**Project: IEEE P802.15 Working Group for Wireless Personal Area Networks
(WPANs)**

Submission Title: comment resolution assignment

Abstract: proposes comment resolutions for a set of CIDs

Comments for CIDs (v5)

Figure 23: Two Part Preamble

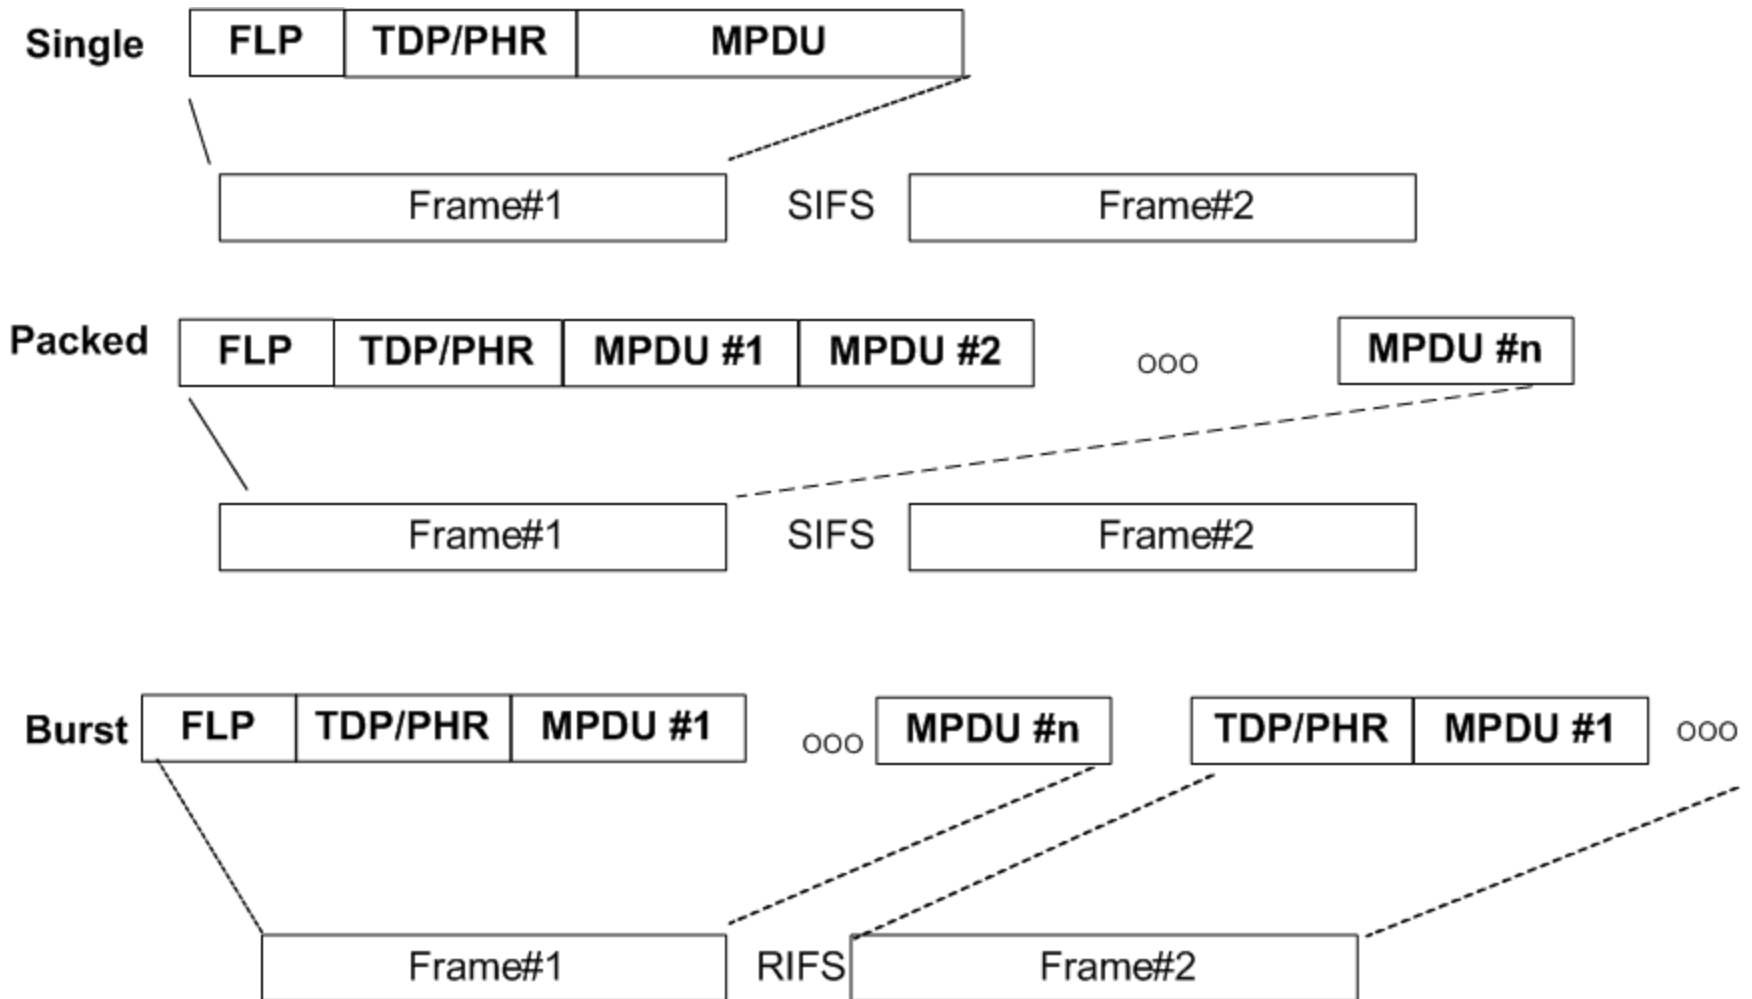
- In Figure 20, in Burst mode, there are two MAC PDU #n. These should be fixed.
- Figure 20 - Burst Mode - shows the same MAC PDU being transmitted twice, in both Frame #1 and #2. This figure does not align with the text
- (SY) In Burst mode, both packets are shown with the label "MAC PDU #n". I believe that the labels should be different

- Redraw the figure with correct PDU numbers.
- replace first MAC PDU #n with MAC PDU #1 and second MAC PDU #n with MAC PDU #2

Instruction to editor: Update Figure 23

- The standard defines one fast locking pattern (FLP) followed by choice of 4 topology dependent preamble (TDP) repetitions for the purposes of distinguishing different PHY topologies.

- After the fast locking pattern, 4 repetitions of one of four TDPs are sent.

- Figure 24: Proposed TDPs for various topology modes
